# CERTIFICATE OF APPROPRIATENESS PLACARD

Changes to previously approved COA (COA-0005-2023), including: shift mudroom north wall, breezeway columns, and wood privacy screen; shorten breezeway eave; enclose west soffit; enlarge north addition window; alter and shift west door; remove east picture window; relocate east door; relocate chimney; relocate mechanical equipment; widen driveway; install front yard fence

525 Watauga St

COA-0123-2023

ELEVATIONS - PROPOSED  
NORTH ELEVATION

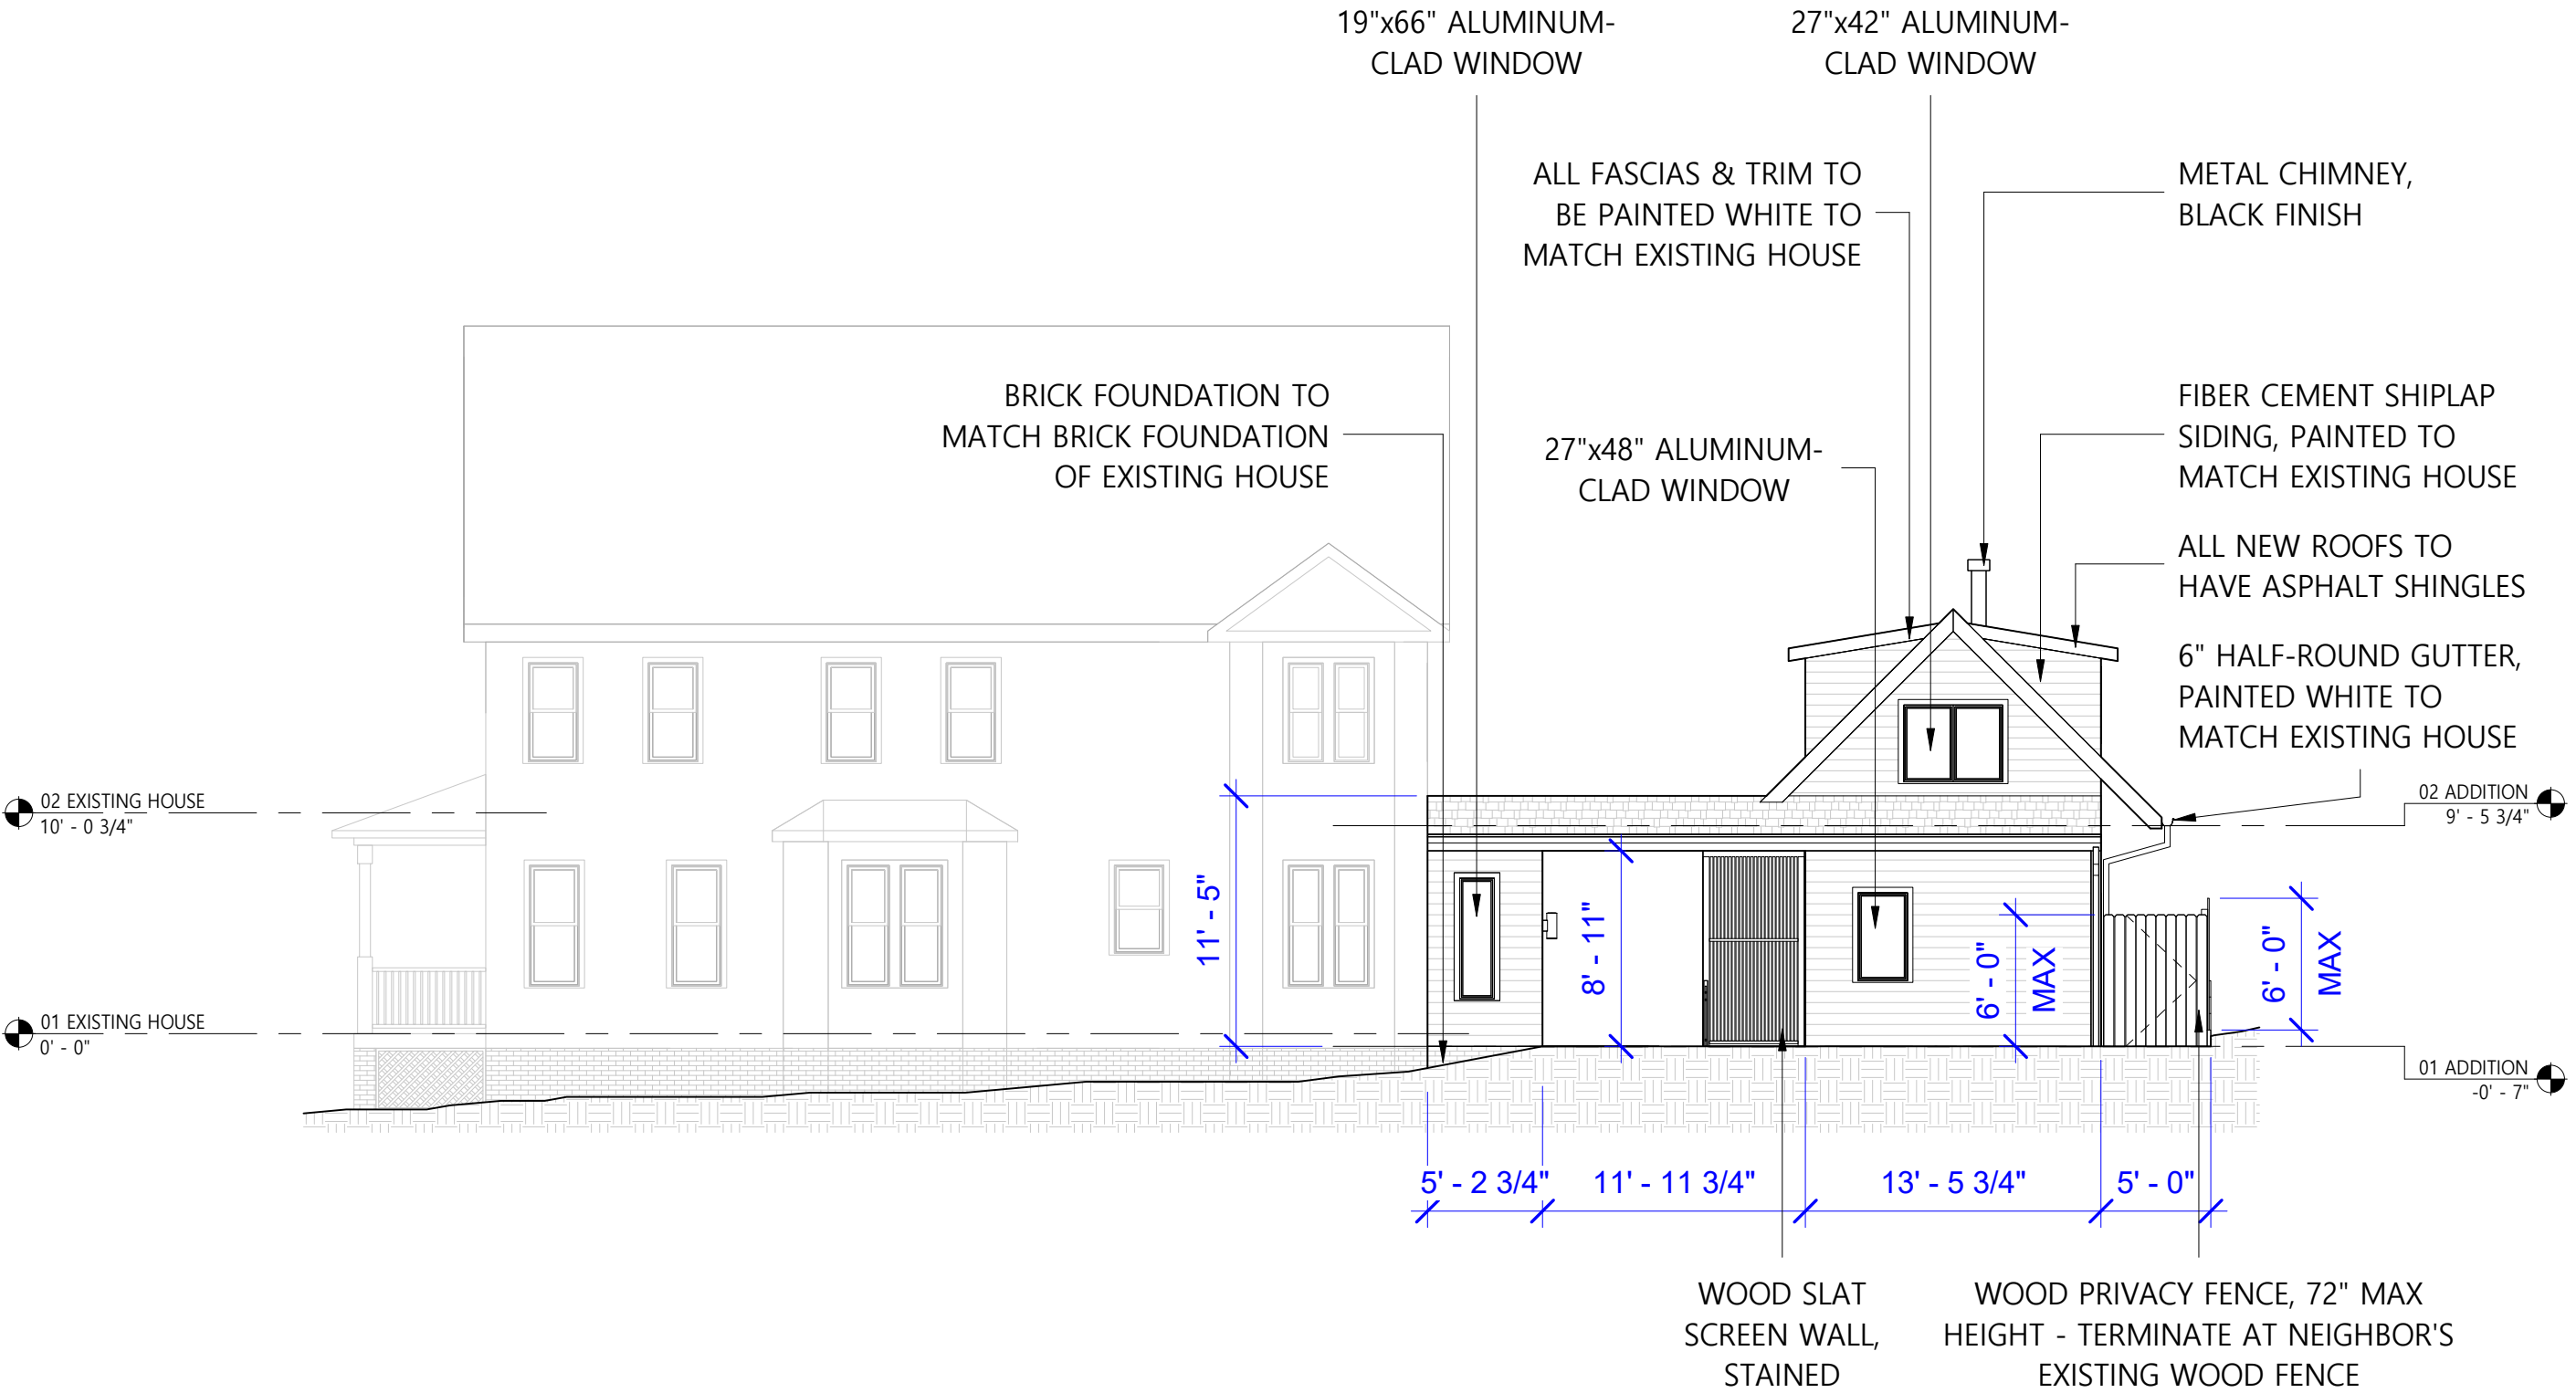
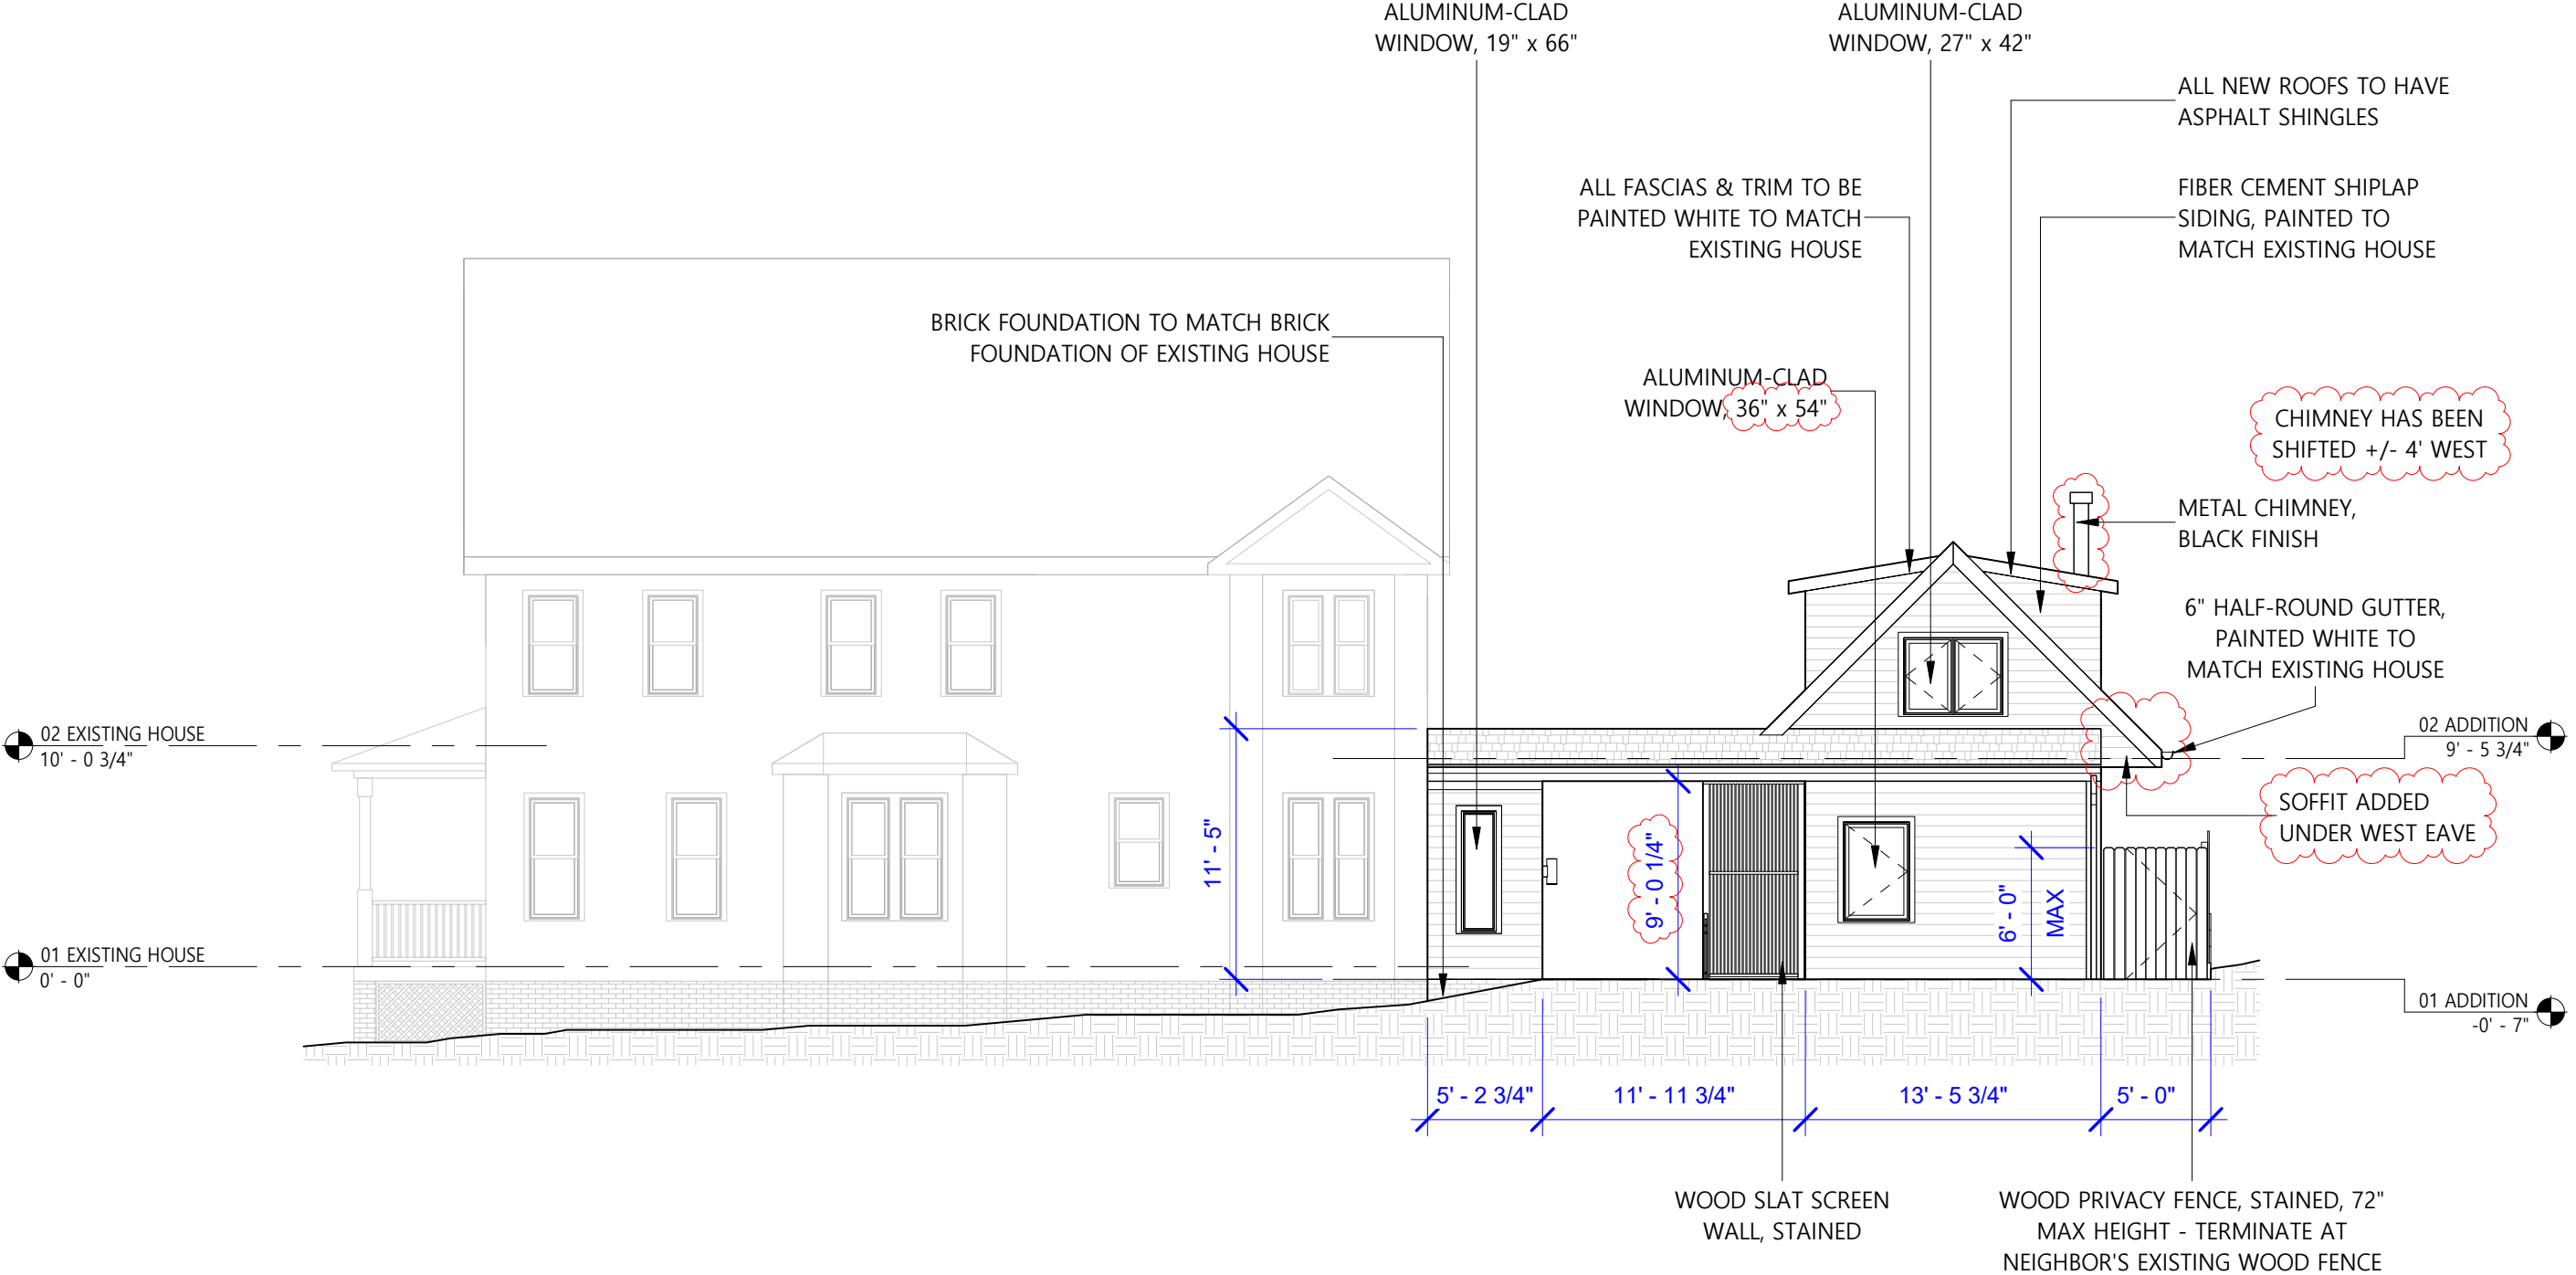
- Chimney has been shifted ~12' N and ~4' W from original location. This is best viewed in elevation - pages 10 & 11 (approved vs. proposed N elevations) and pages 14 & 15 (approved vs. proposed W elevations).

- Revisions to window & doors on N & E elevations of addition.
  - On N elevation the approved window was increased in size from 27"x48" to 36"x54". Best viewed on pages 10 & 11 (approved vs. proposed N elevations)

- Addition of soffit under existing W eave of addition. This is best viewed on pages 10 and 11 (approved vs. proposed N elevations).
- Revised retaining wall and fence location on E side of lot (Watauga St). After reviewing the approved condition along with the existing site conditions, we realized we can stop the retaining wall at the NE corner of the lot so that the fence can turn and enclose the front yard without the need for a retaining wall on the Watauga street-side side of the property since the grade is essentially level with the concrete stair landing at that line. This is best viewed on pages 4 and 5 (site plans). Note that the fence drawn on the approved site plan wasn't approved, but we believe this new layout addresses all of the concerns expressed about congruity to date as the fence runs a straight line, extends all the way to the S property line and then terminates into the house instead of the porch.

VIEW FROM CUL-DE-SAC

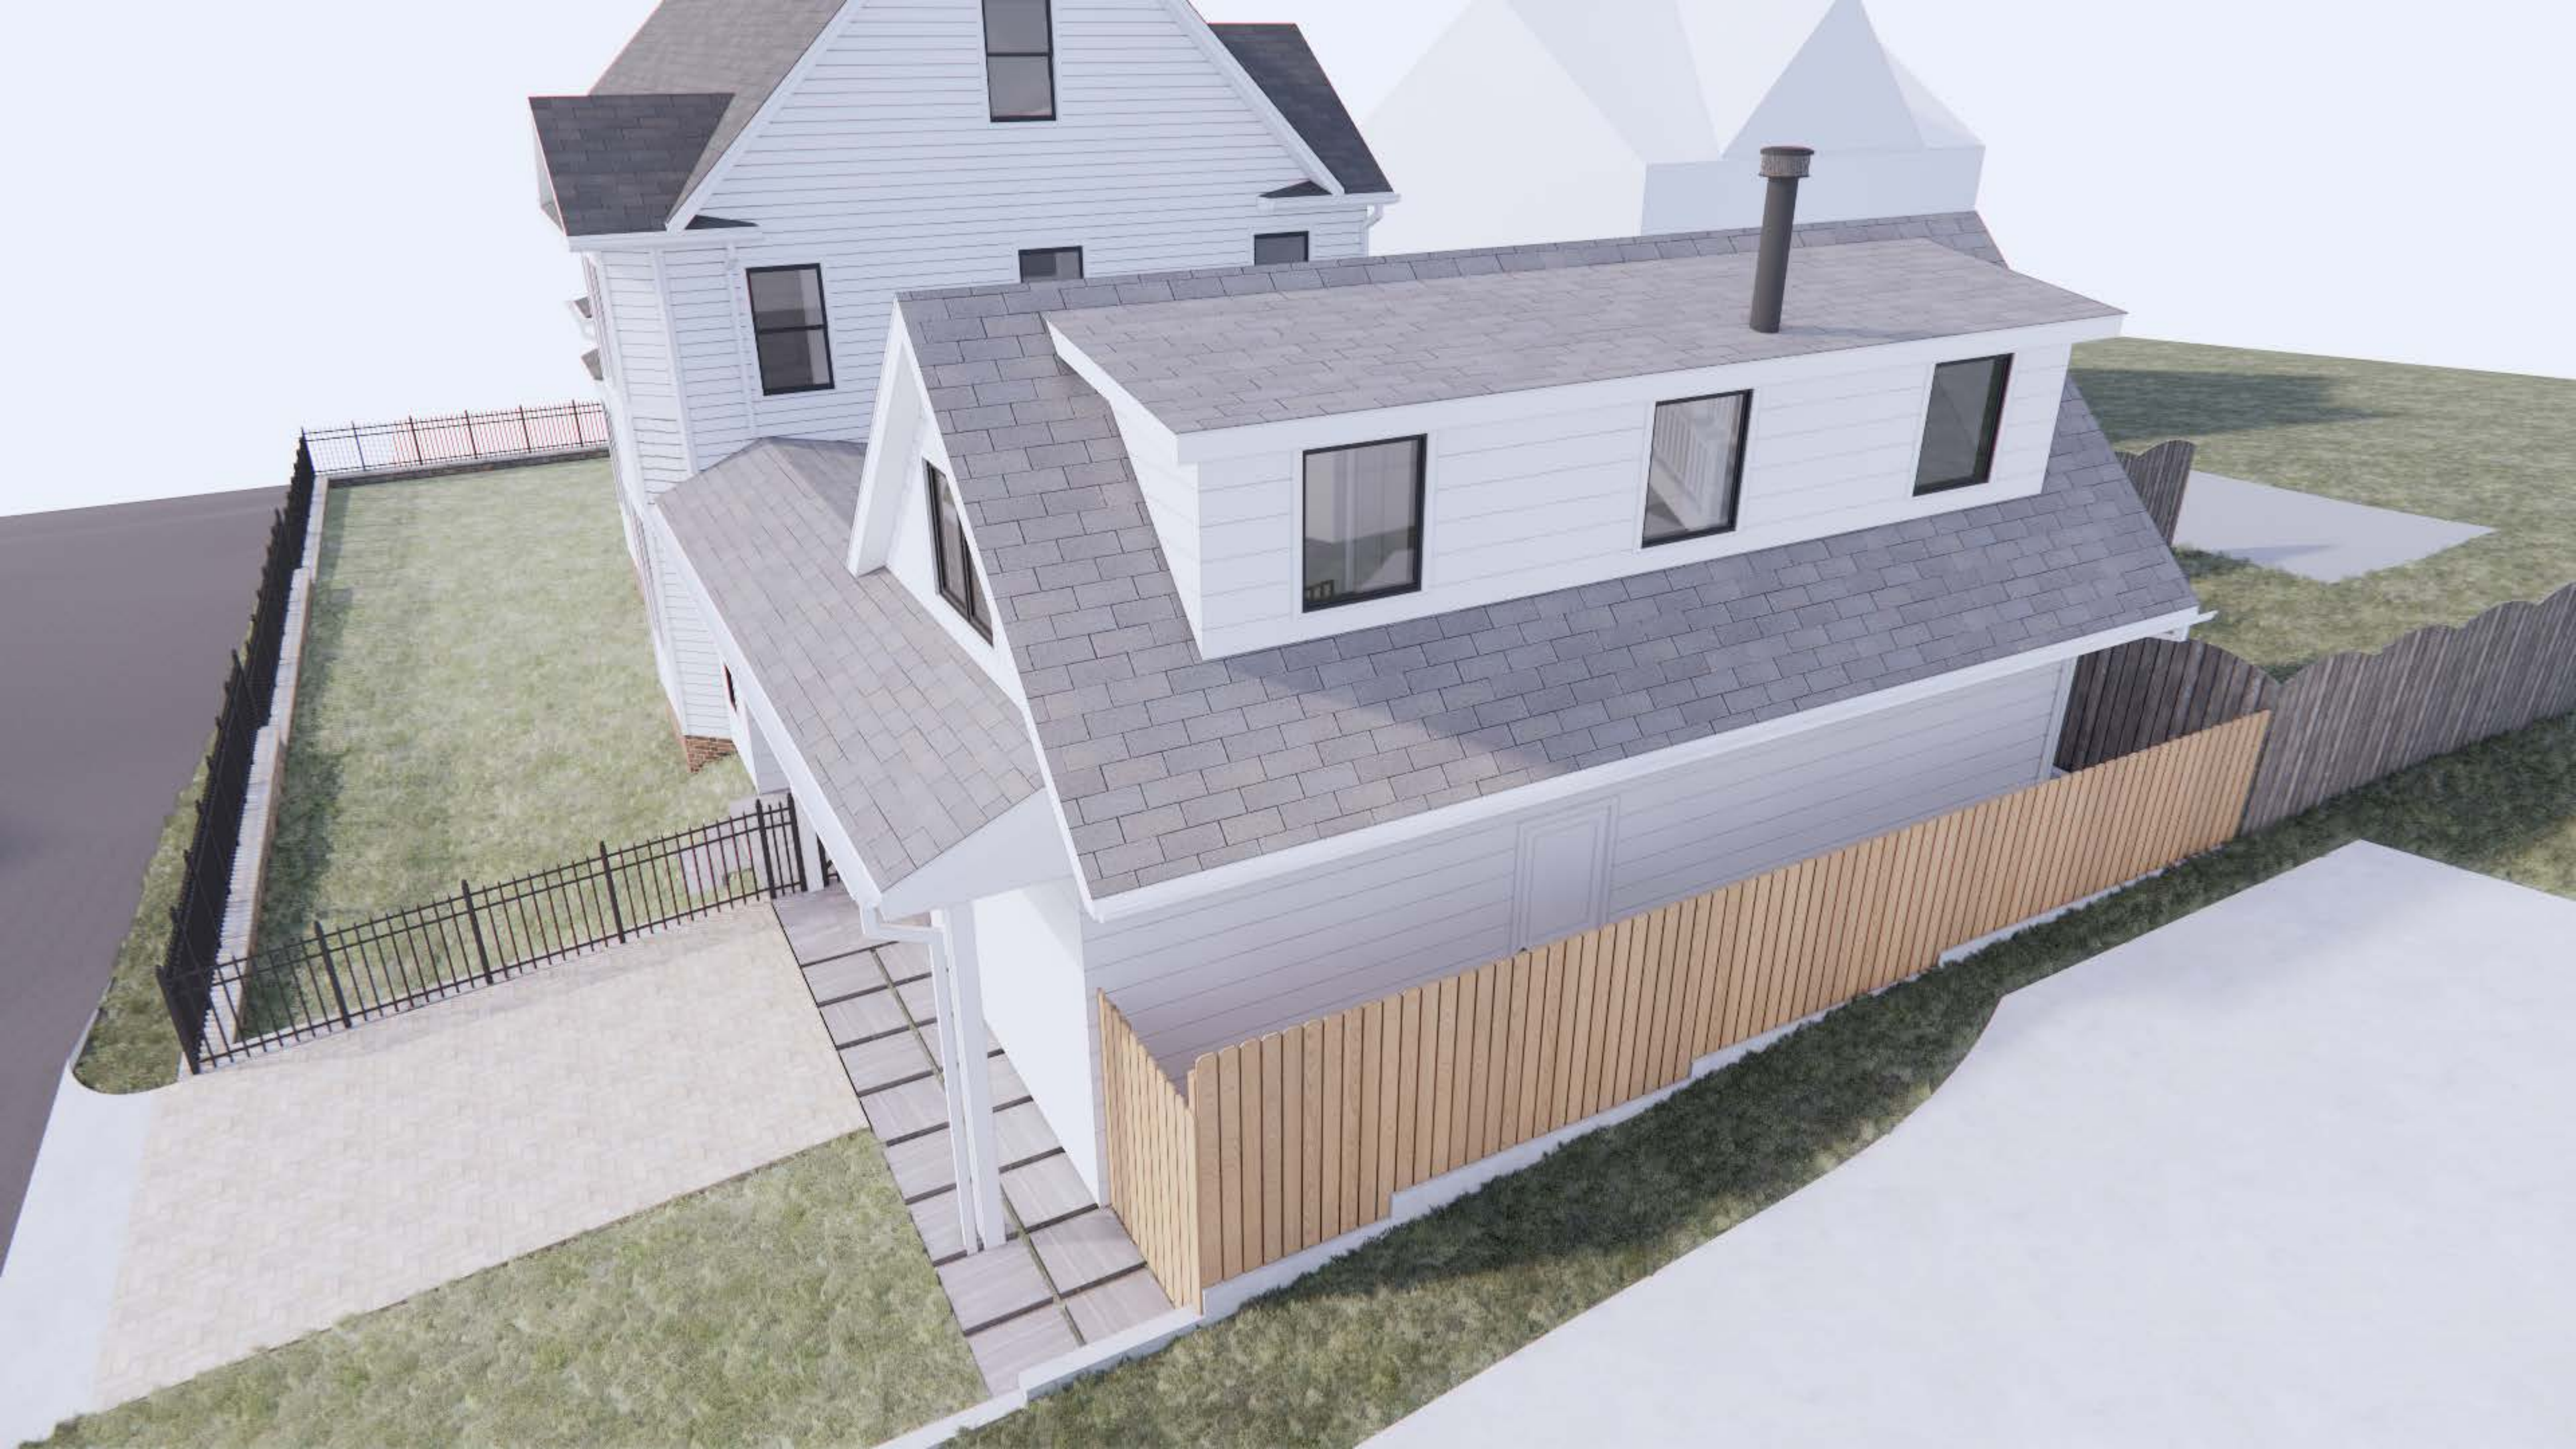
- On E elevation ~~the large sliding door system has been split - there were 1 large panel, now there are 2 door panels and 2 window panels. The overall size/location is similar.~~ The swing door on this elevation has been shifted N ~4' so that it is now detached from the sliding system. These revisions are best viewed on pages 12 & 13 (approved vs. proposed E elevations) as well as renderings on page 18 and 19 (approved vs. proposed).
